STAFF REPORT KETCHUM PLANNING AND ZONING COMMISSION REGULAR MEETING OF JANUARY 24, 2023

PROJECT: Appellation Hotel (formerly Harriman Hotel)

FILE NUMBER: P22-059 and P22-059A

SUBJECT: Design Review Comments Response

Figure 1: Comparison of Wall Height near Gateway Plaza

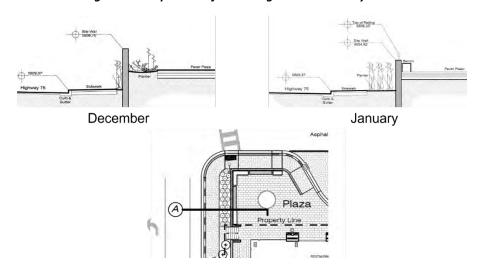
In December, staff noted that the plaza area seemed closed off to the public and was more of an amenity for hotel guests than the community. One of the reasons for this comment was the extent and height of the wall around the plaza. Figure 1 below shows a cross section comparison of the December proposal and what is proposed today. At this location of the cross section, the height has been reduced by 2 feet from approximately 8 feet to 6 feet. The current proposal does include a 12+ inch railing along the top of the wall. At the corner of Hwy 75 and River Street, the wall is approximately 4.5 feet tall.

Staff believes the reduction in wall height is positive, however, staff is still concerned with the closed off nature of the plaza due to the use of concrete board form walls. The city engineer has also raised concerns about the wall height at the corner and site distance visibility. Staff acknowledges that the height of the wall is a function of the finished floor elevation of the paver patio and requirements for fall protection. Staff does not recommend adjustments to the finished floor elevation of the patio, but does recommend a more transparent wall/railing configuration from the finished floor of the paver plaza to the necessary fall protection height surrounding the Gateway Plaza. This could be

an open metal or wood railing or strategic placement of landscape planters with open railing in between.

Figure 7: Design Principles, Gateway Area Mass and Scale Study

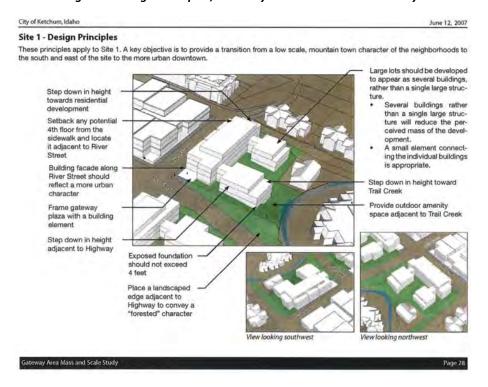
The Gateway Area Mass and Scale Study contemplated a four-story building with a step back of the fourth floor towards Trail Creek as shown in Figure 7 below.

OVERALL SITE PLAN

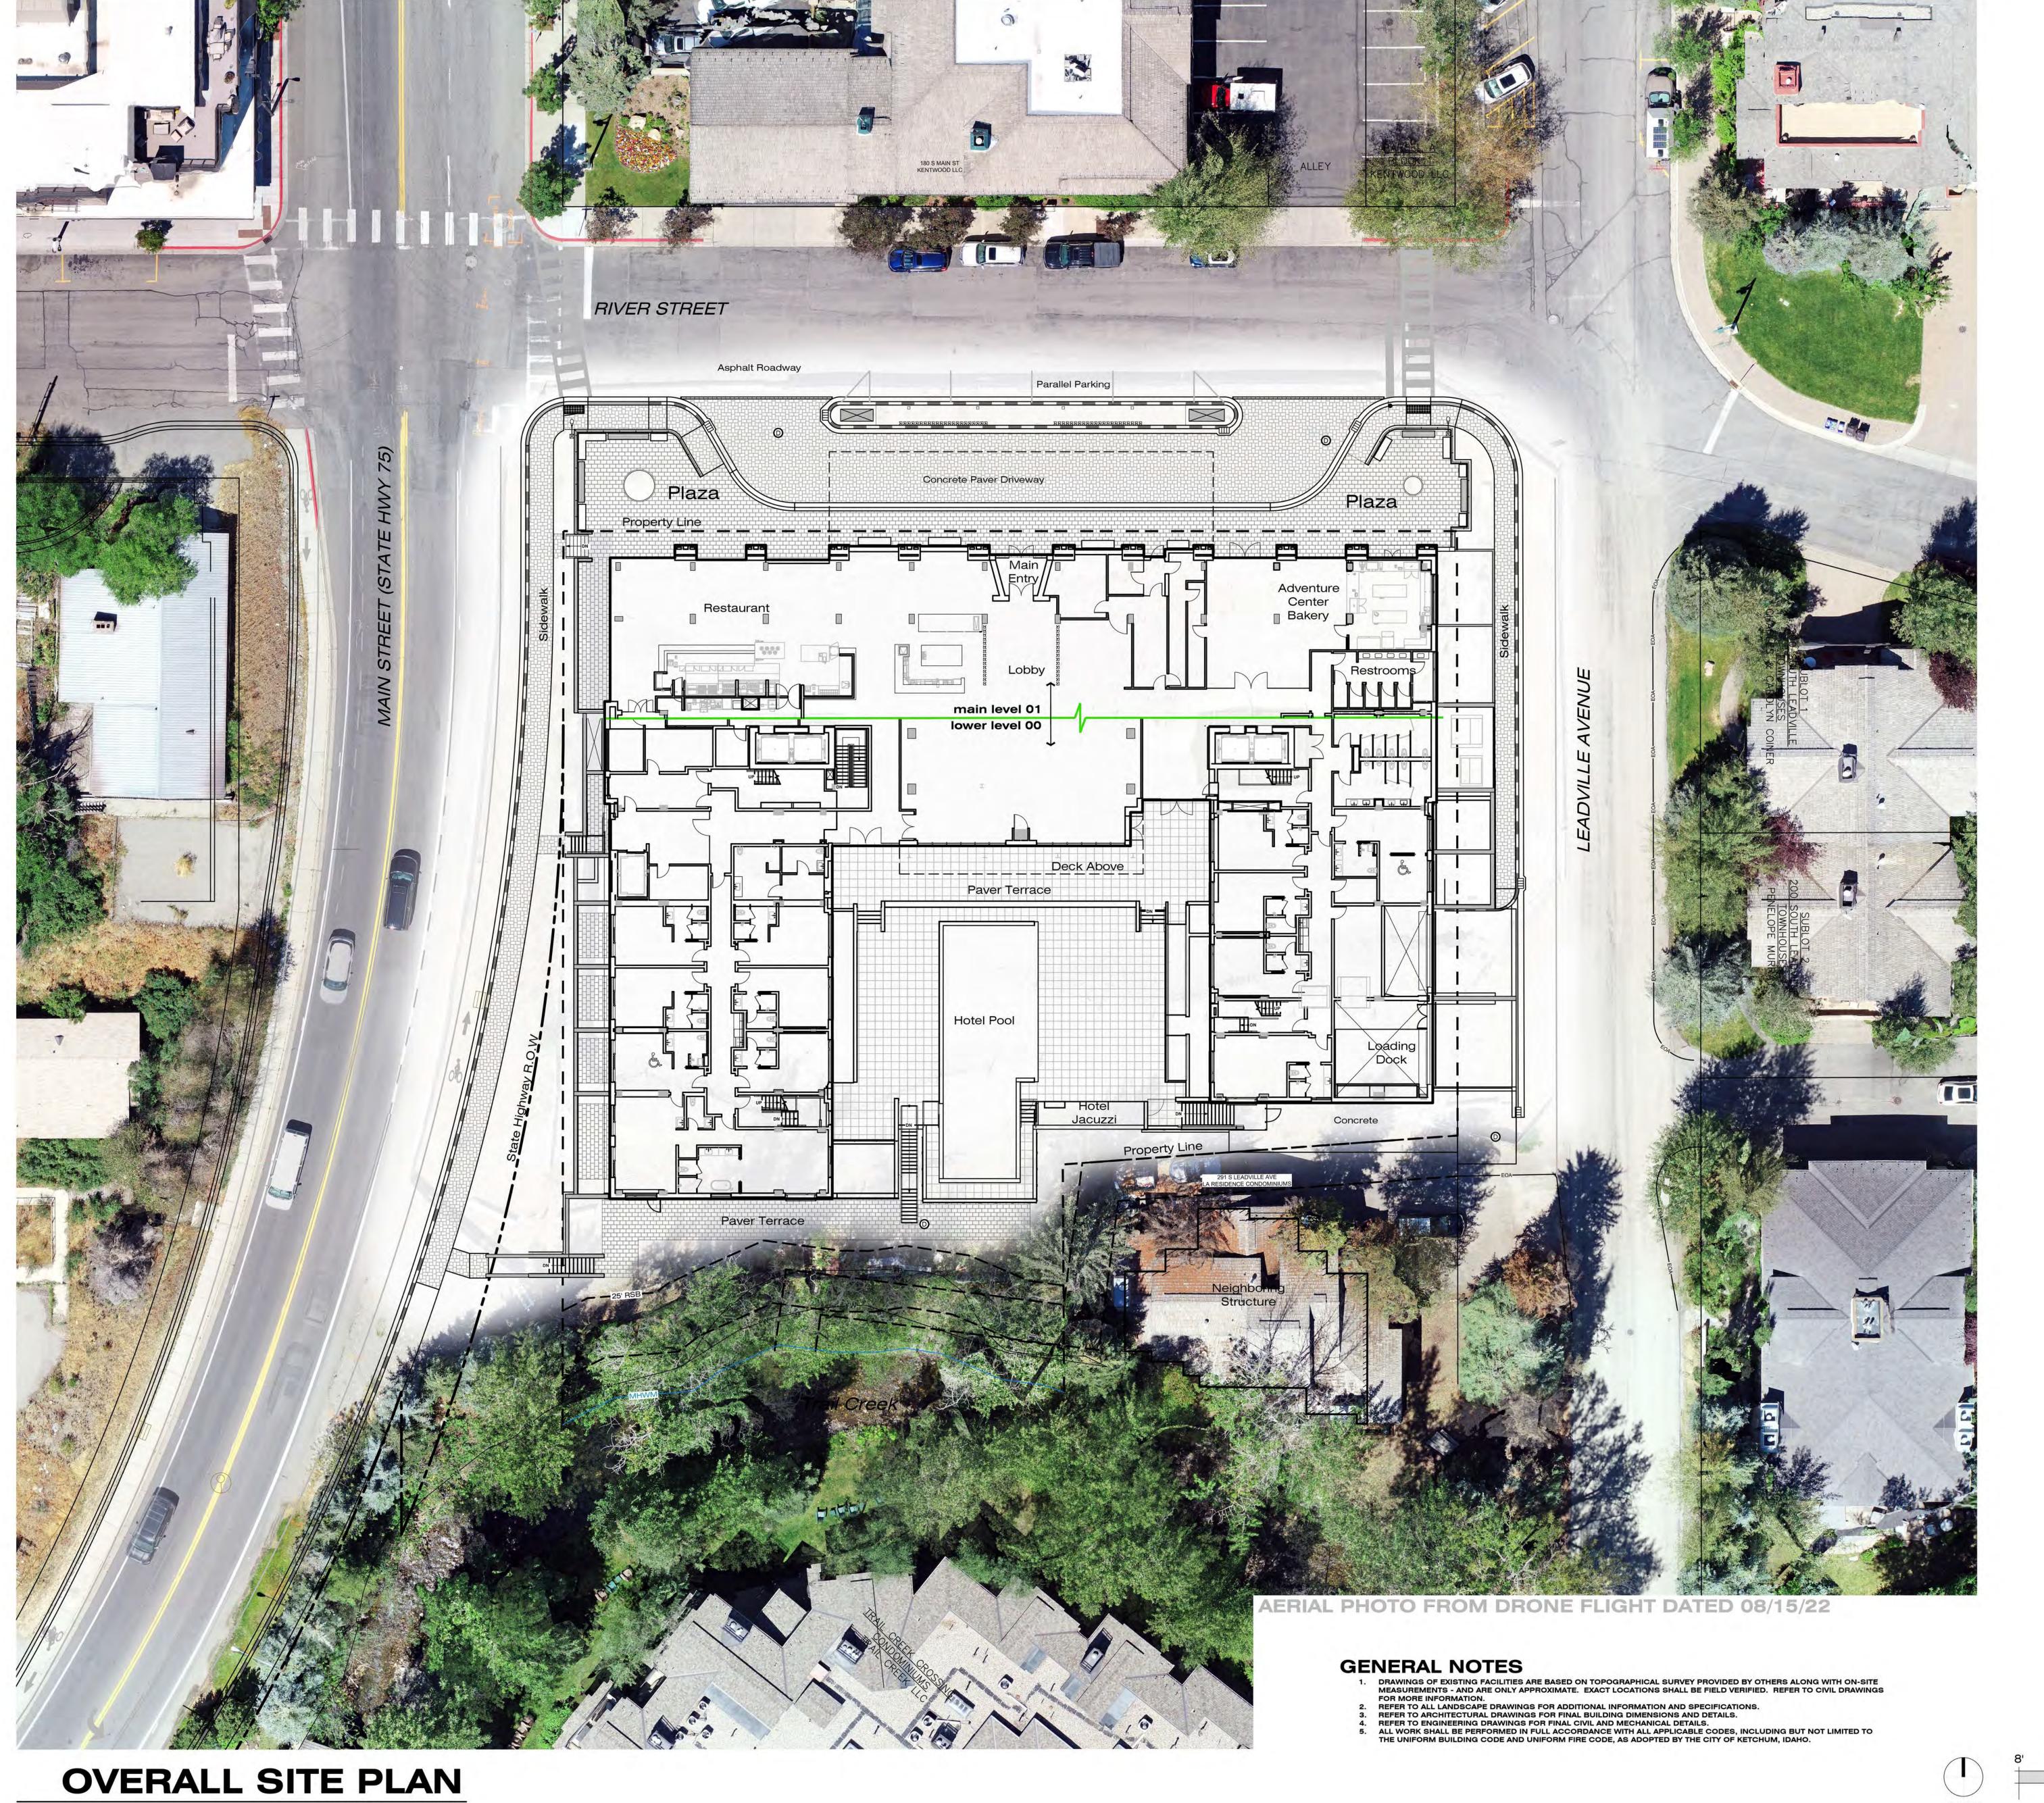
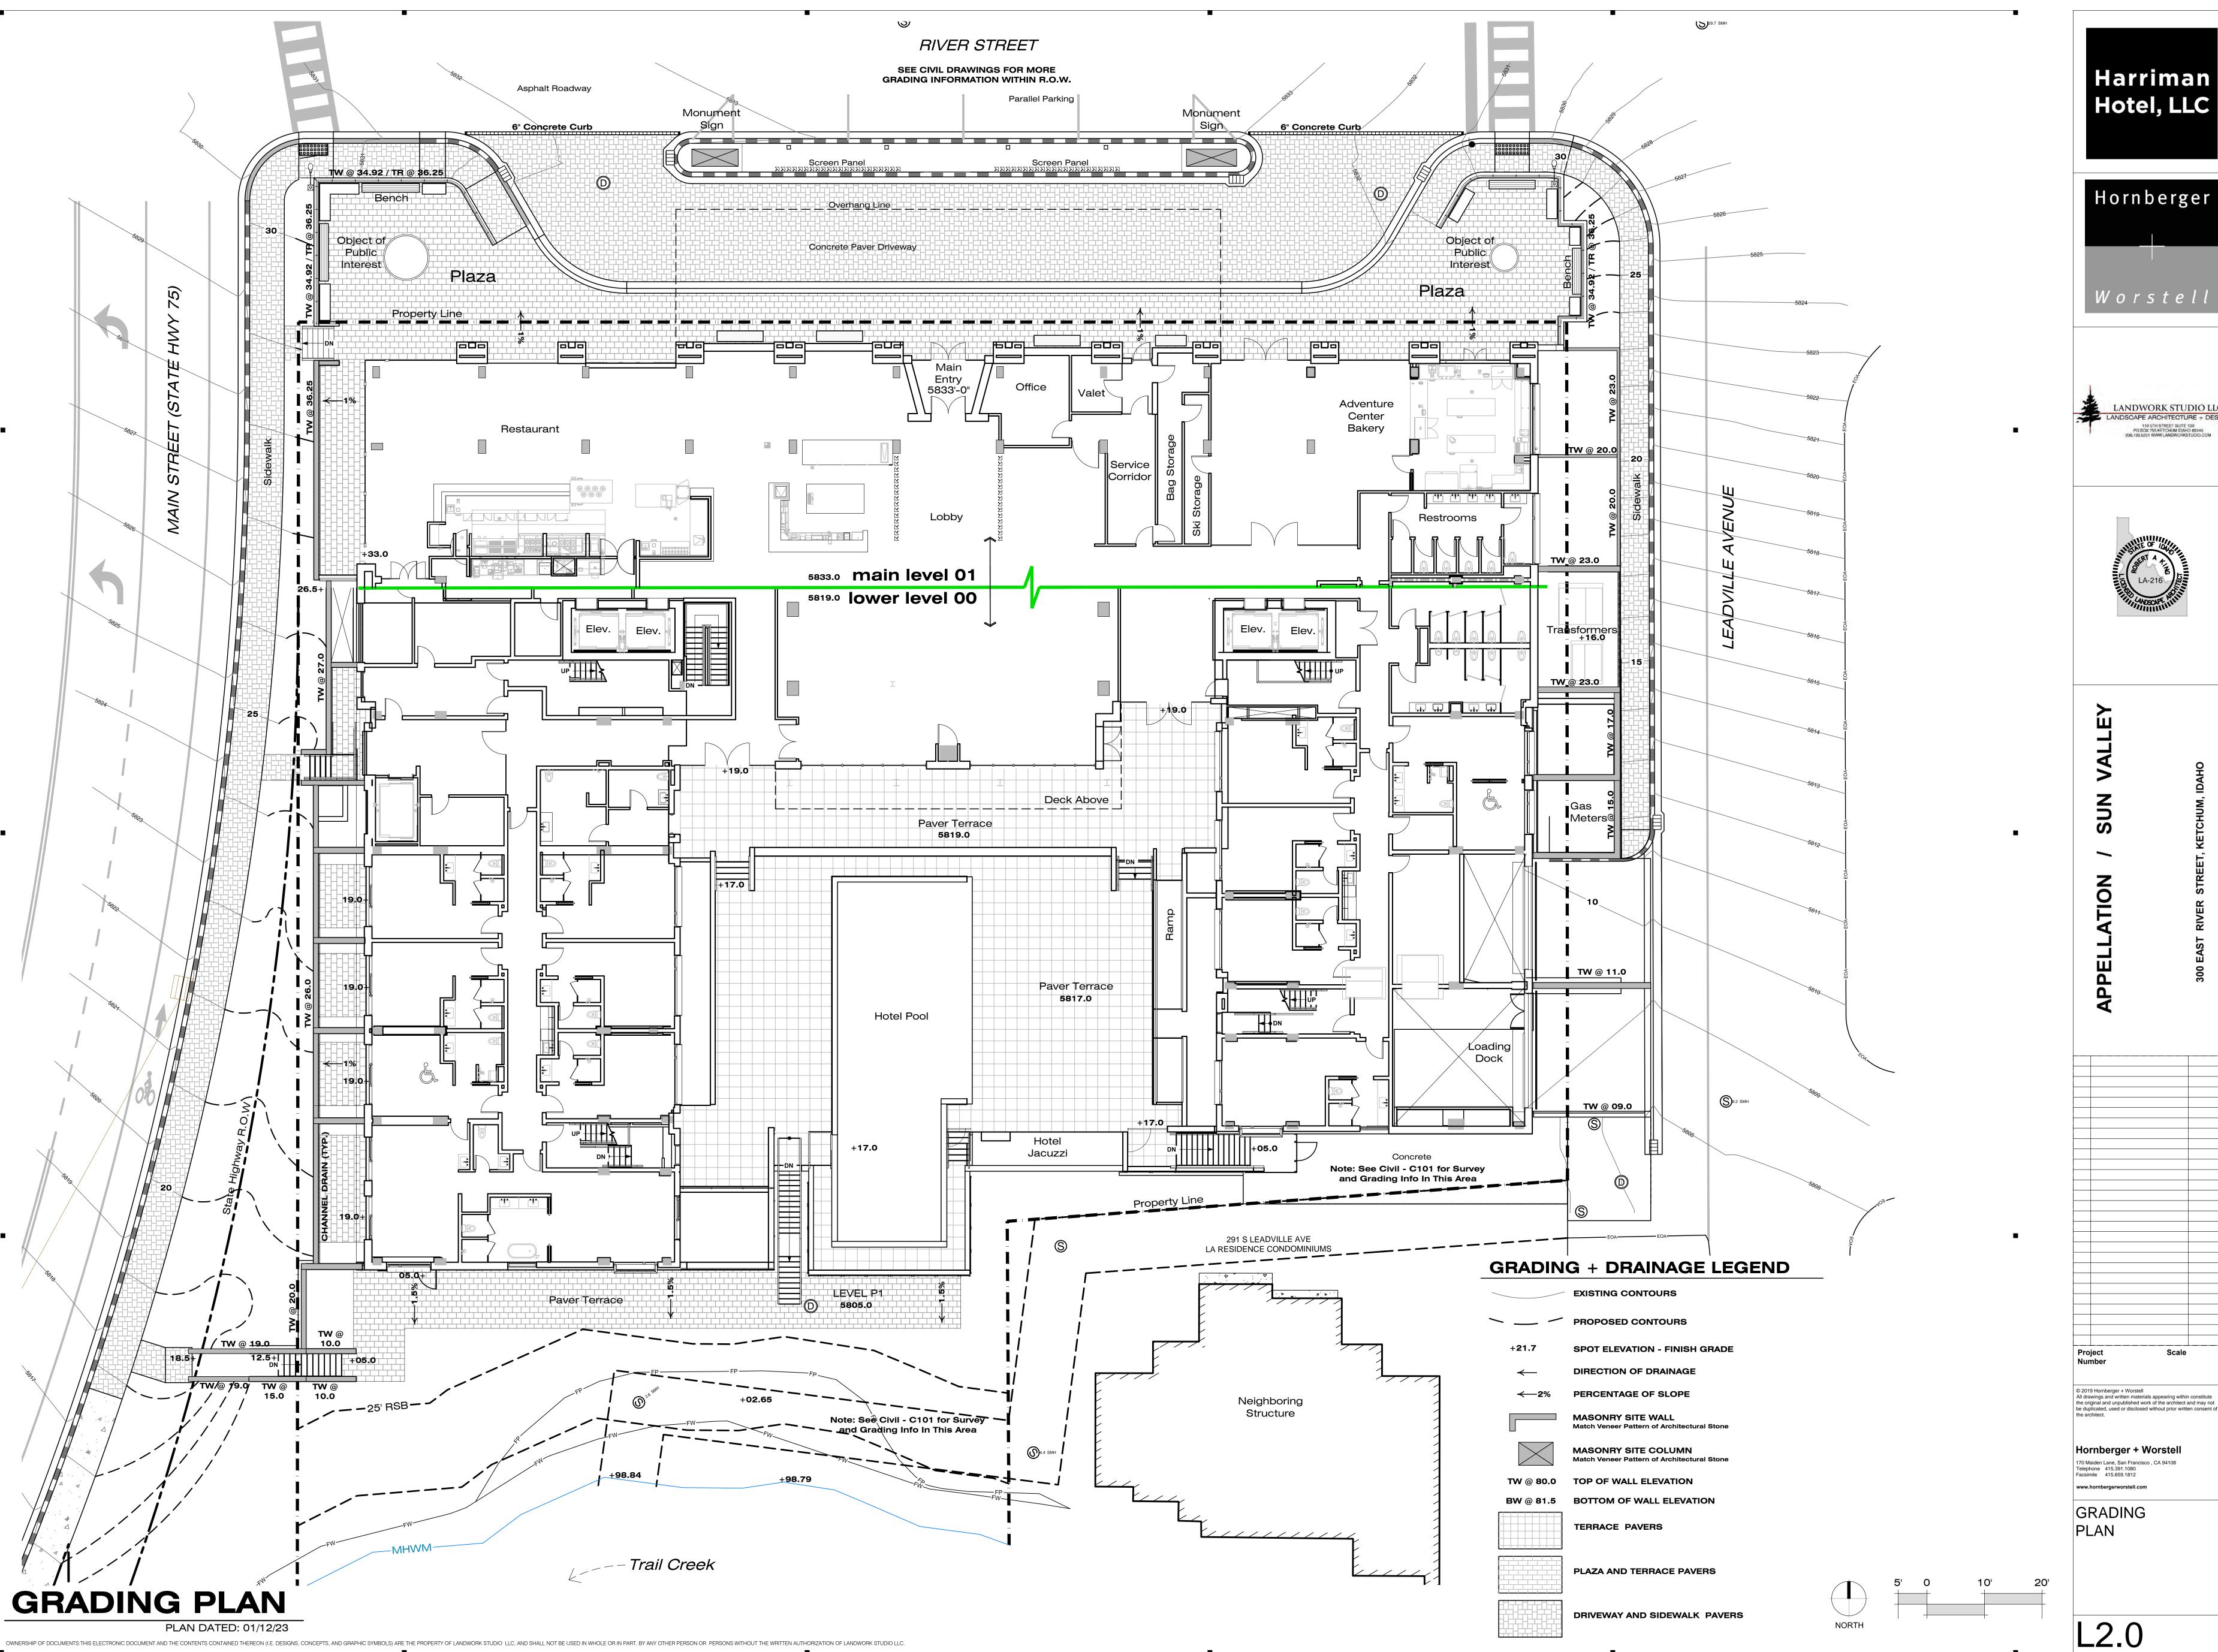
As shown on Sheet L3.0 of Attachment B, the current proposal has reworked the pool deck including a rotation of the pool 90 degrees and relocated the jacuzzi. The size of the jacuzzi has reduced and is in a similar area of the pool deck as the original approval. A landscape buffer has been reintroduced between the pool deck and the adjacent property to the east, although the buffer is much smaller than originally approved in 2008 as shown in Figure 4 above. As dimensioned on Sheet L1.1 of Attachment B, the current proposal sets the pool deck 6.5 feet from the property line to the

east allowing for some low-lying landscaping and a gravel walking path which provides egress to Leadville Ave. Staff believes this configuration is an improvement from the initial proposal in December and is supportive of the change. Staff does recommend consideration of creeping vines or other wall vegetation along the walls facing the adjacent residential property to provide relief and screening of the hard surface. Design Review Criteria #26 states "Substantial landscaping is to be provided, which is in scale with the development and which provides relief from and screening of hard surfaces. Total building surface area and street frontage will be considered when determining whether substantial landscape is being provided. (Landscape shall be defined as trees, shrubs, planters, hanging plants, ground cover, and other living vegetation)".

- Site plan updated to show revised Pool and Pool Deck Plan; opens L3.0 up riparian buffer zone.
- Landscape Plan updated to show more developed landscaping in buffer area and Trail Creek access feature.
